Intel[®] 82801EB I/O Controller Hub 5 (ICH5) / Intel[®] 82801ER I/O Controller Hub 5 R (ICH5R)

Specification Update

November 2007

Document Number: 252517-028

Figure 5.

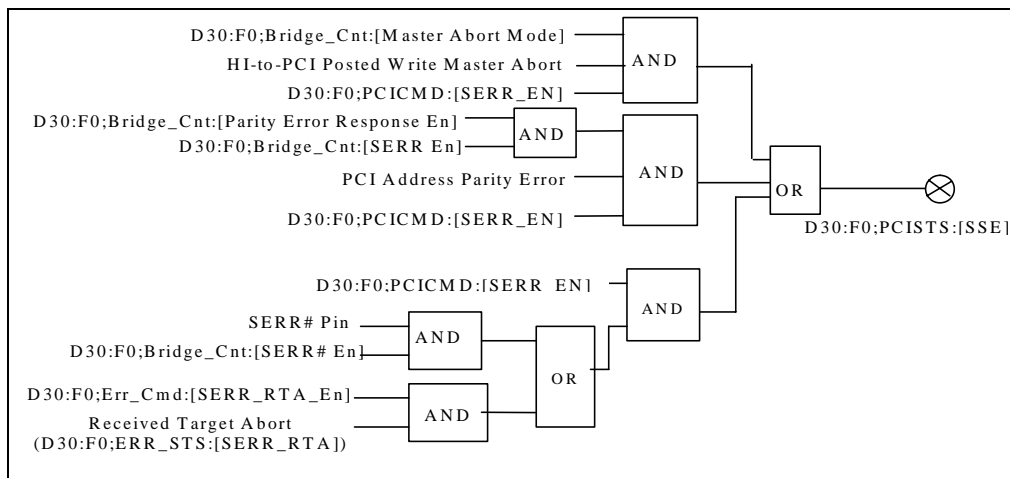
6. SERR# Figure Correction

The Figures 5-7 are inaccurate and is being replaced with the following figures:
